Project Name: CFPUA Water Street Infrastructure / PS 9 Improvements

Subject: TRC Response Letter

CAPE FEAR PUBLIC UTILITY AUTHORITY
WATER STREET INFRASTRUCTURE / PS9 IMPROVEMENTS
 GENERAL
INFORMATION AND PLANS FOR TRC REVIEW

C8
OF 57

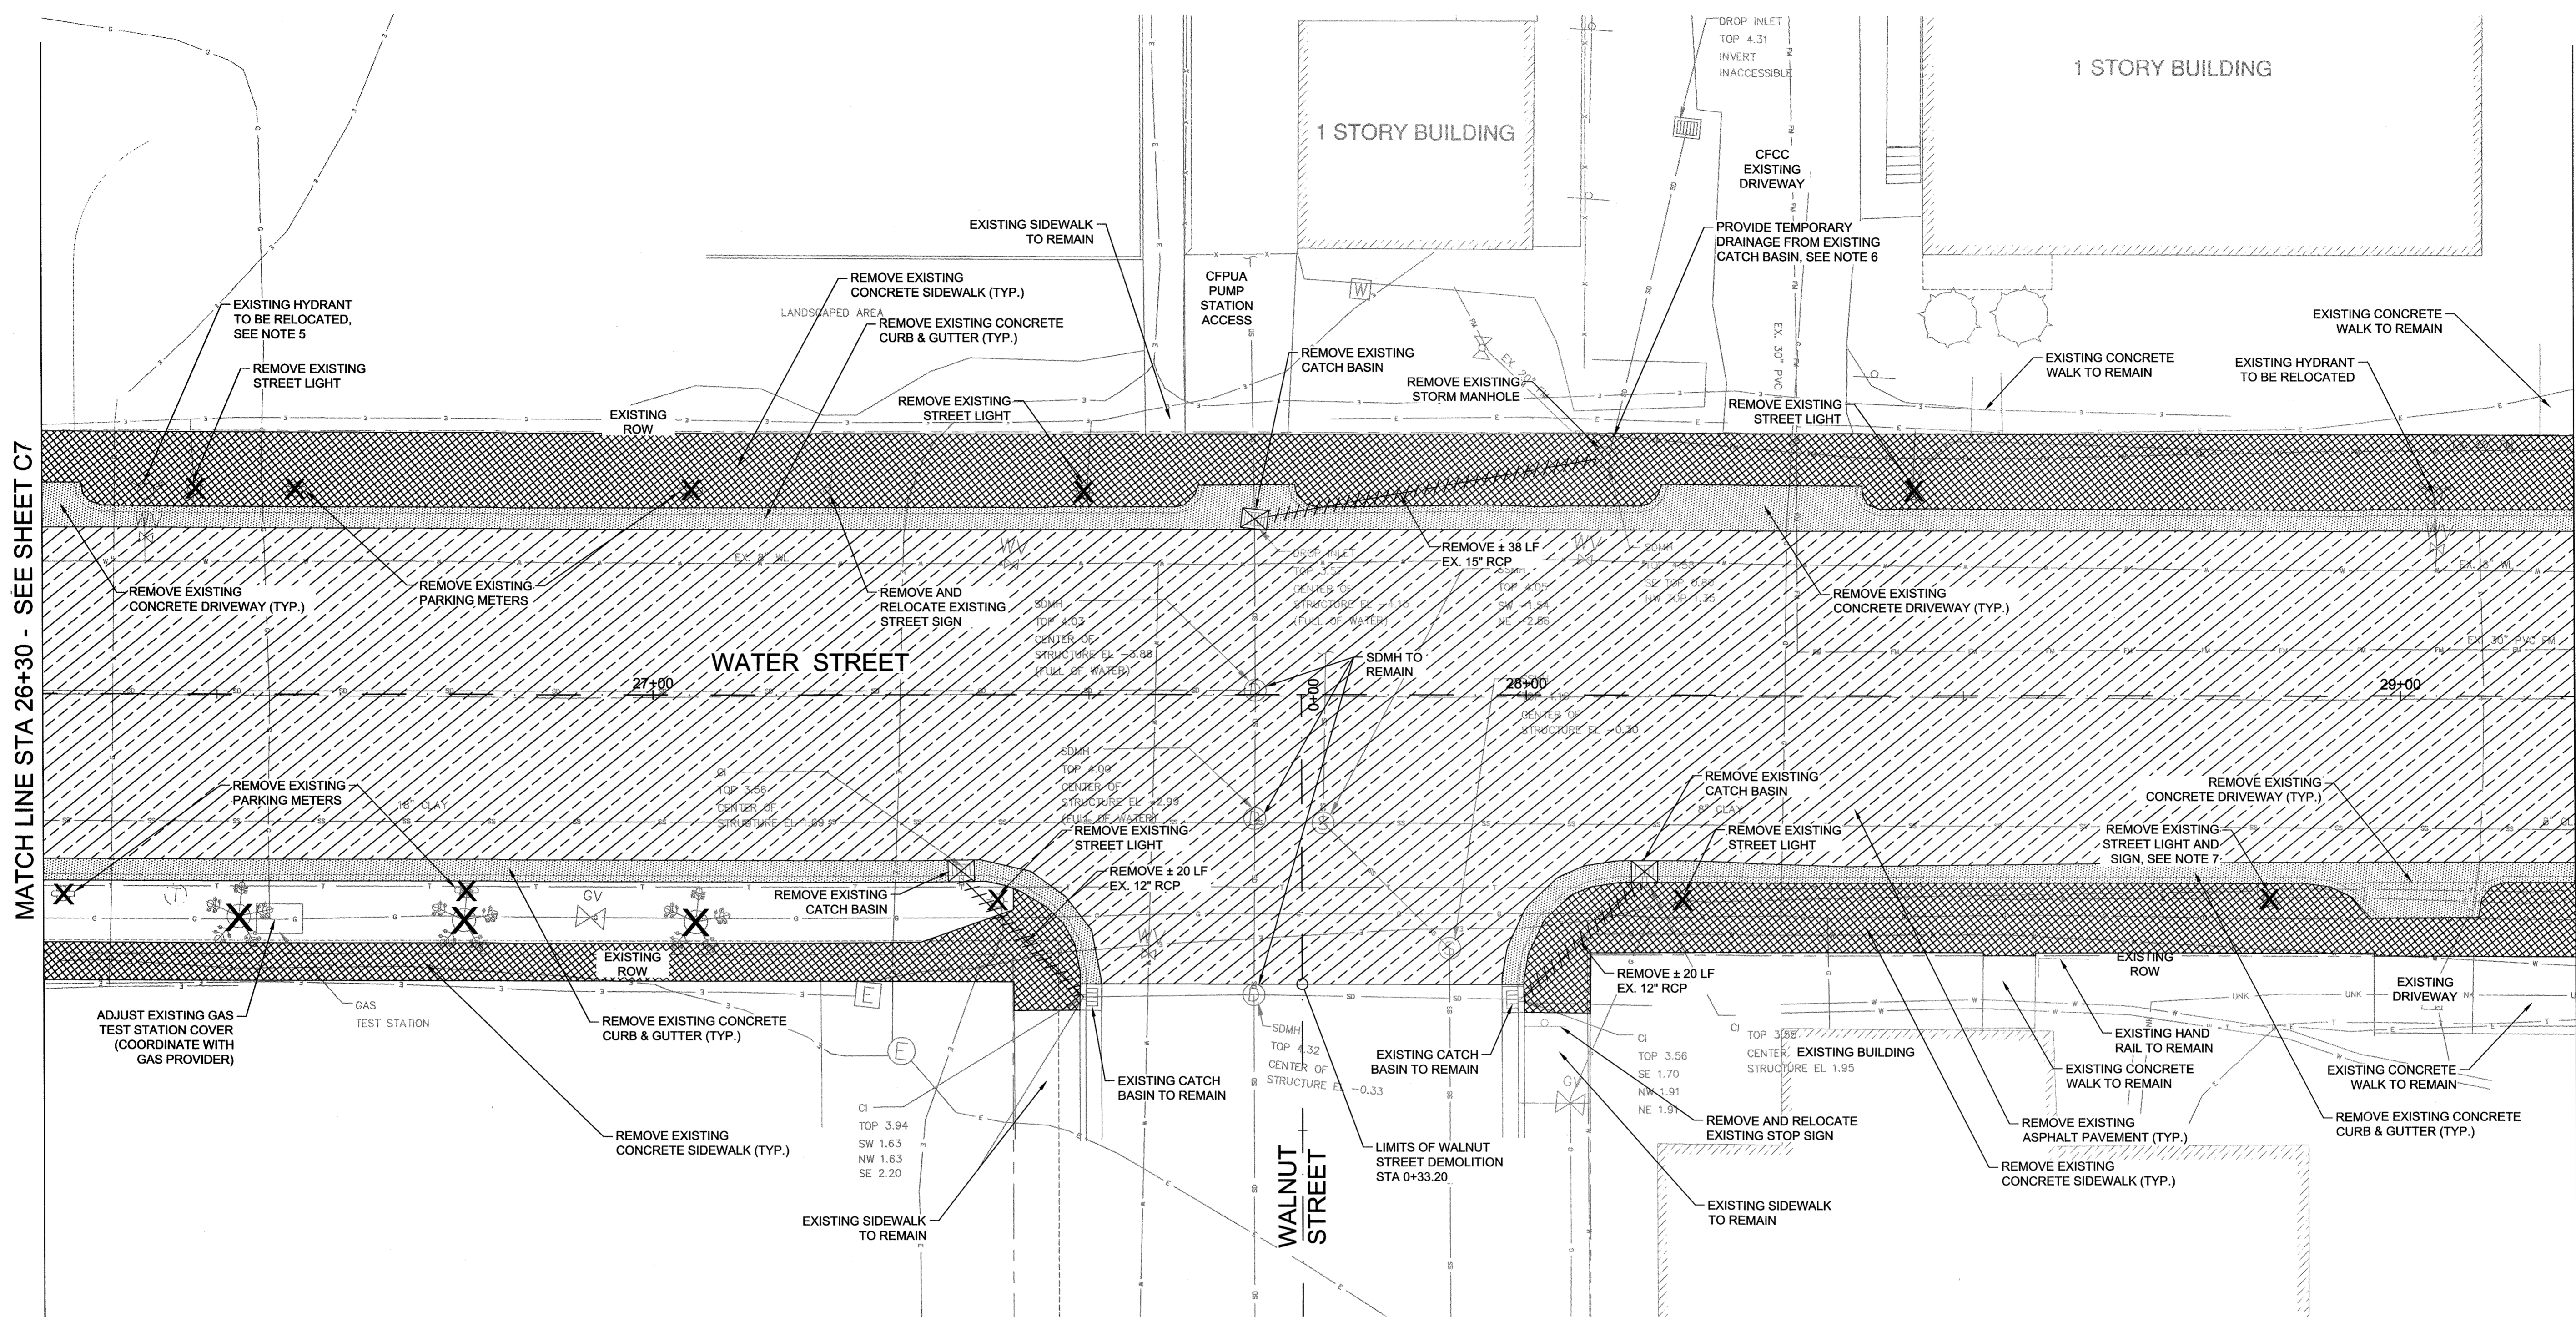
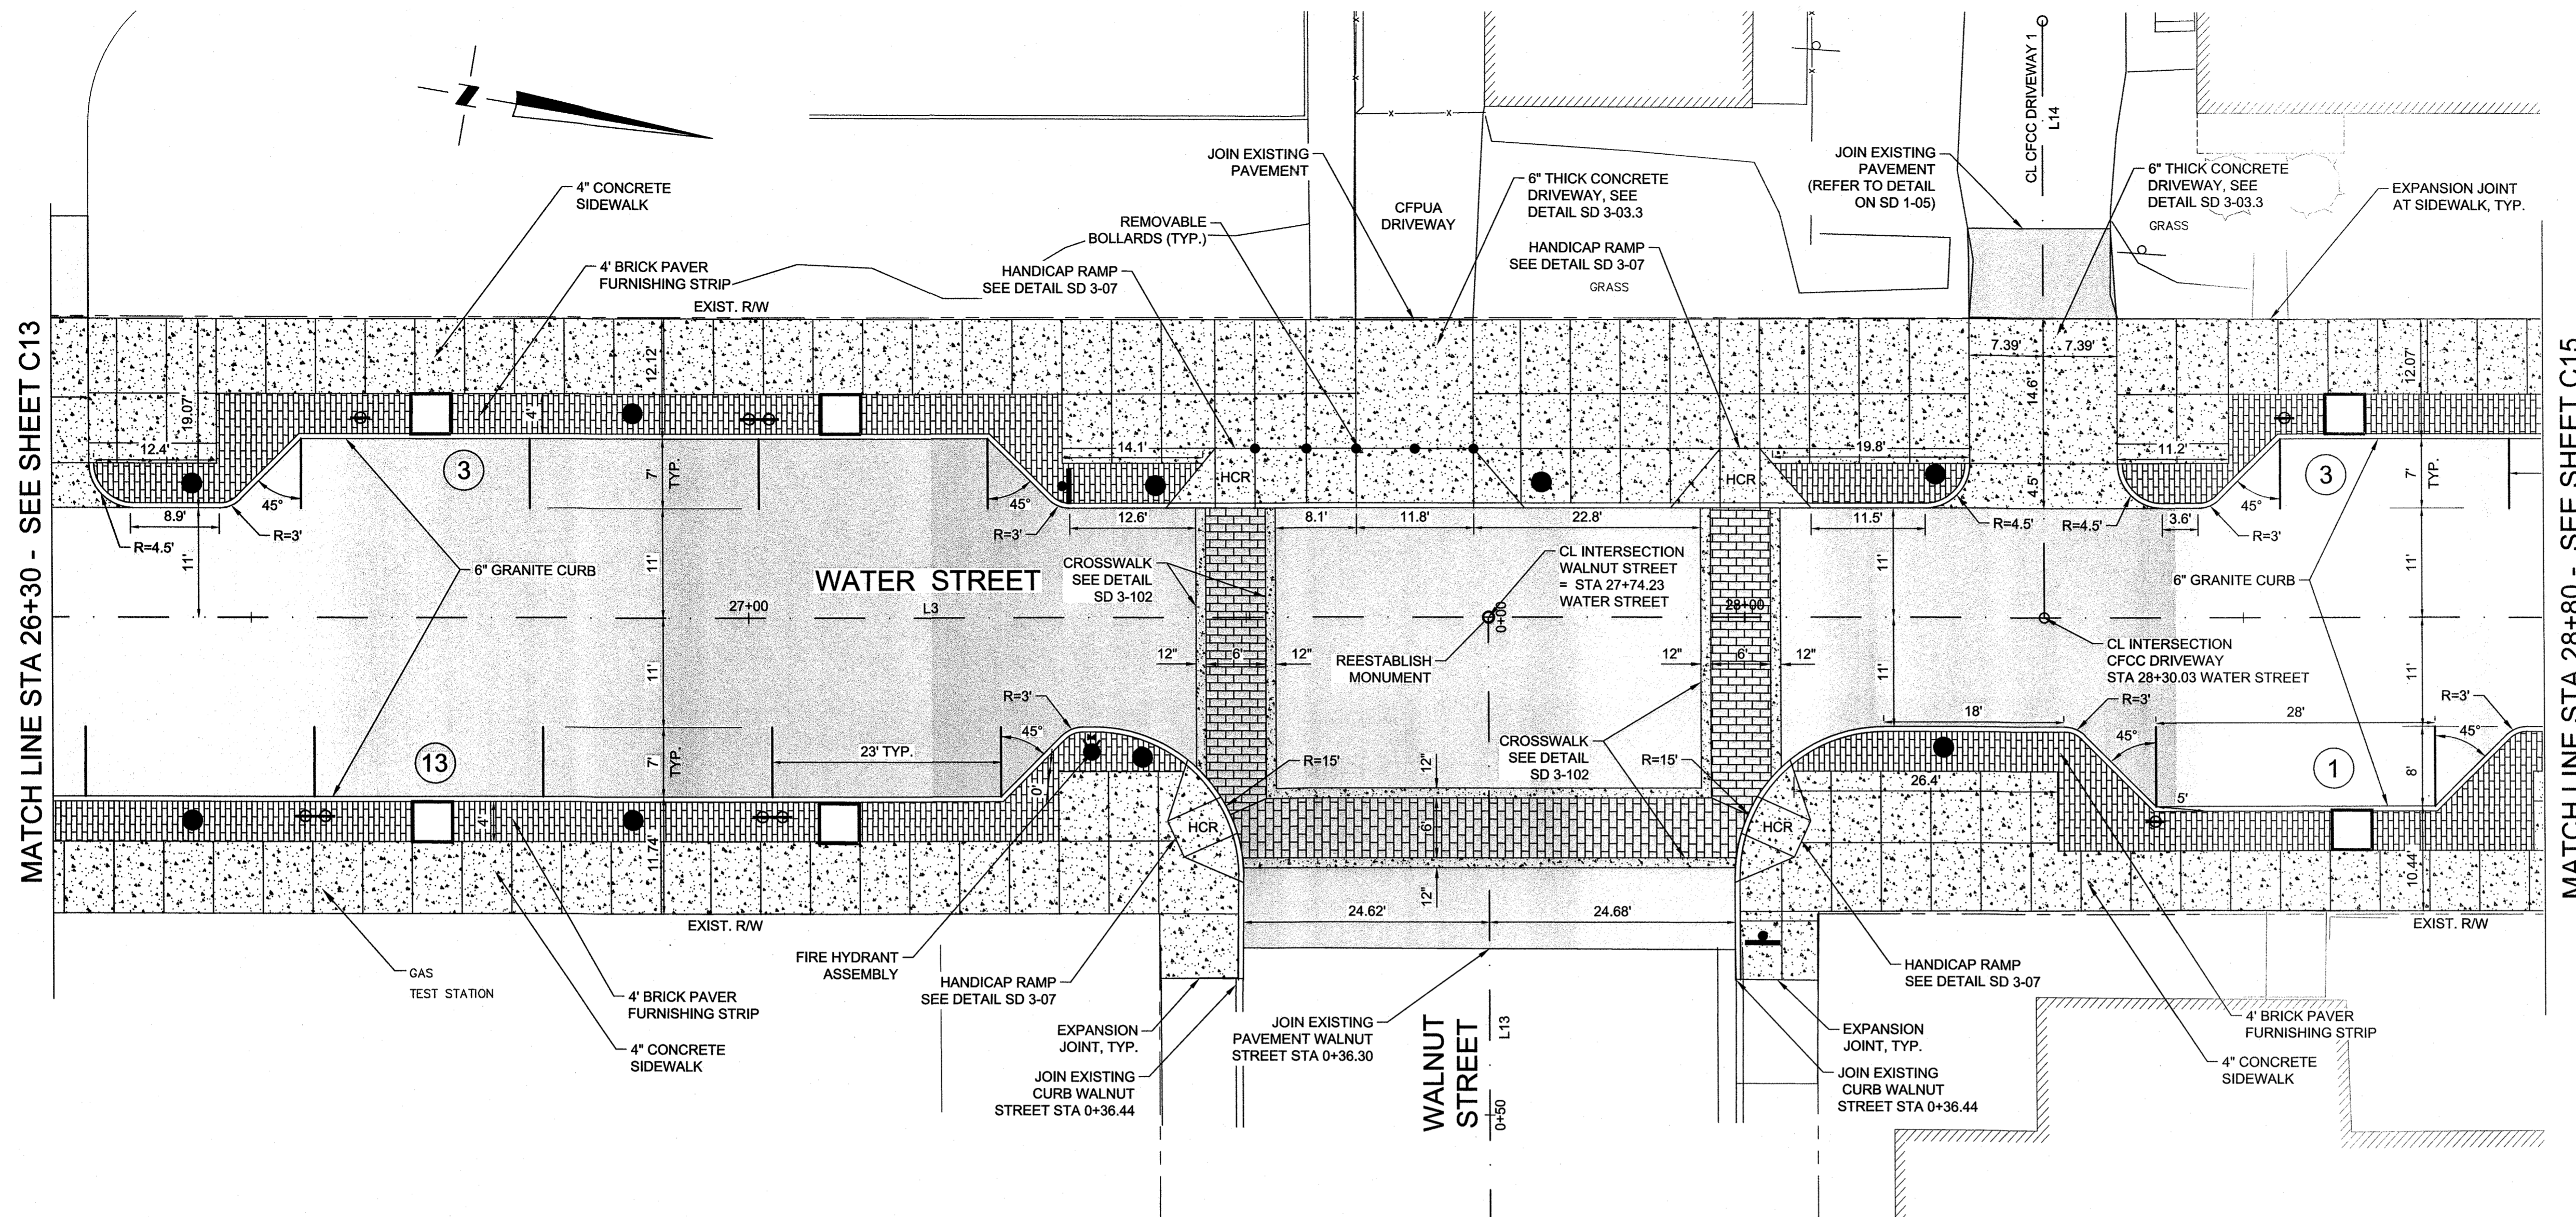
23. Identify any existing parking meters and marked parking stalls on N Water St on the plan.

See Attachment E for the WK Dickson street scape plans for the intersection of N Water St and Walnut St, post-development. Sheet C-8 shows the WK Dickson demolition plan for the intersection in front of Pump Station 9 including existing parking meter locations and marked parking stalls. Sheet C-14 shows the approved street scape with proposed parking meter locations and marked parking stalls. Please note that this Pump Station 9 project does not include the removal or installation of any parking meters or any intersection/parking stall improvements. All intersection and streetscape modifications are designed by WK Dickson as part of the City's street scape plan and we only show them on our site plans for coordination with this Pump Station 9 project.

C14
OF 57

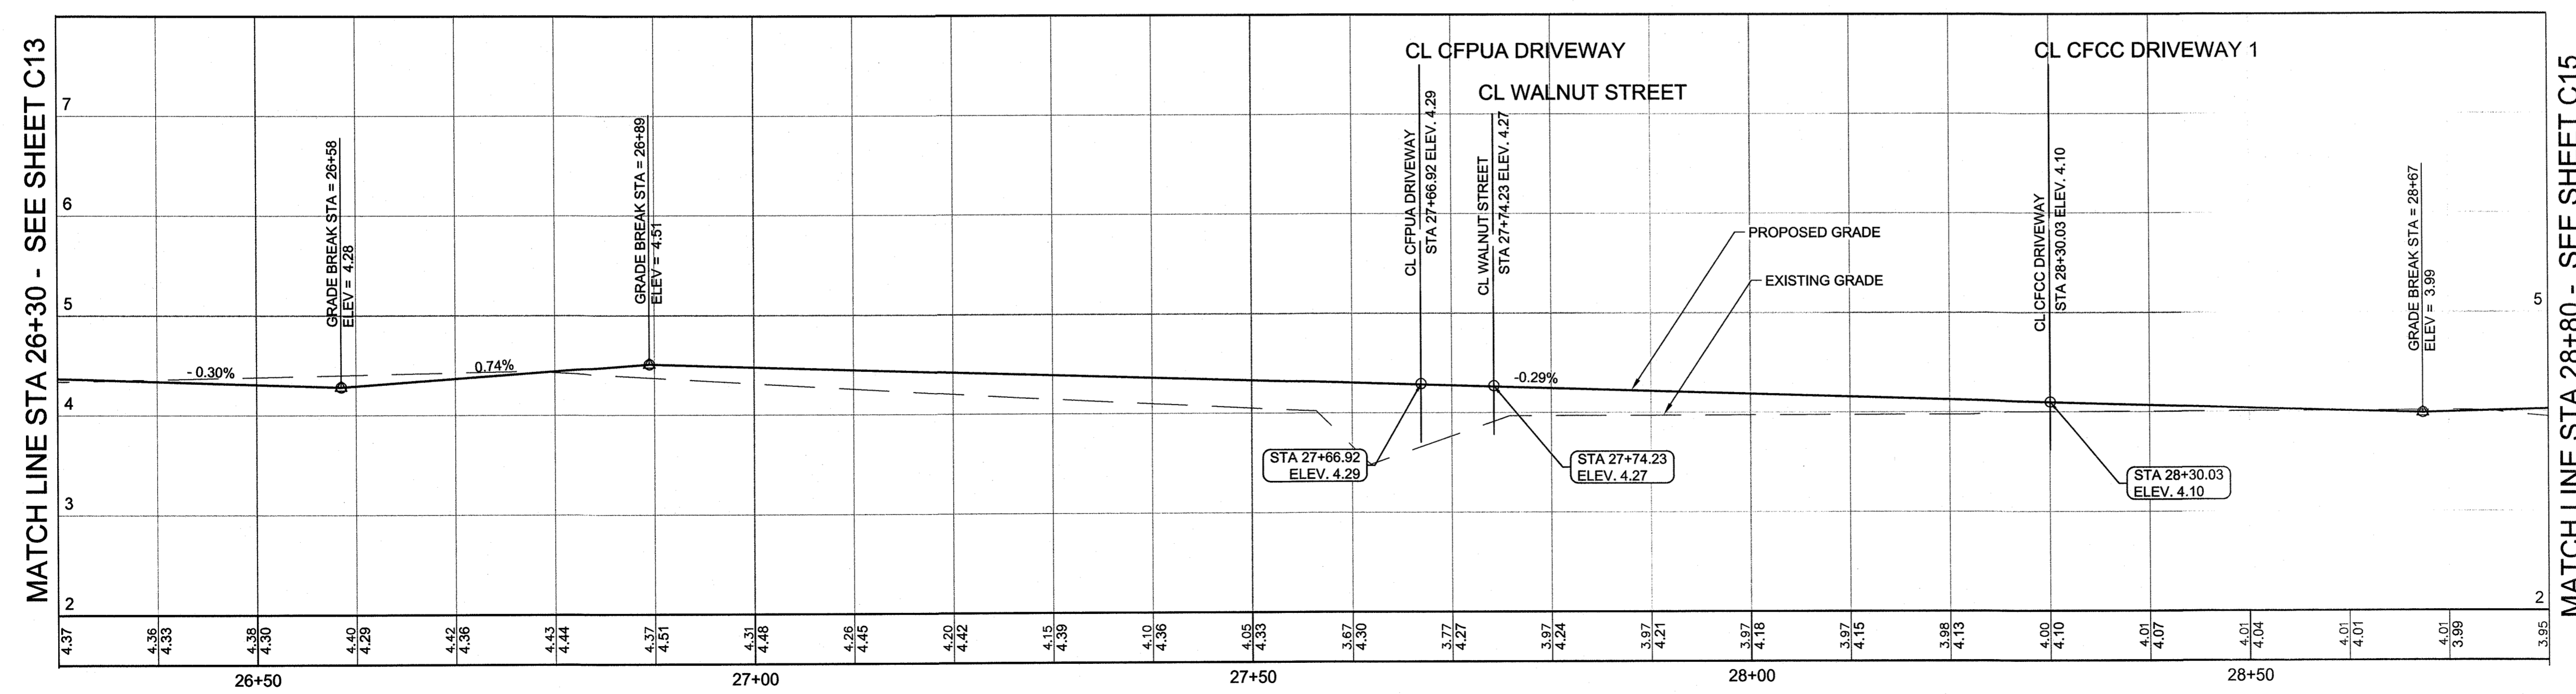
- f. Provide sidewalk detail SD 3-10 on the plan. [Sec. 18-529(b)(2) CofW LDC] 7. Provide curbing detail SD 3-11 on the plan. [Sec. 18-529(b)(2) CofW LDC]

- c. Dimension driveway widths and tapers. [Sec.18-530 CofW LDC]
See Attachment E for WK Dickson street scape plans. Sheet C-14 shows a dimension of 11.8' for the CFPLA access driveway width. Sheet C-49 shows a width of 13' for driveway flares.
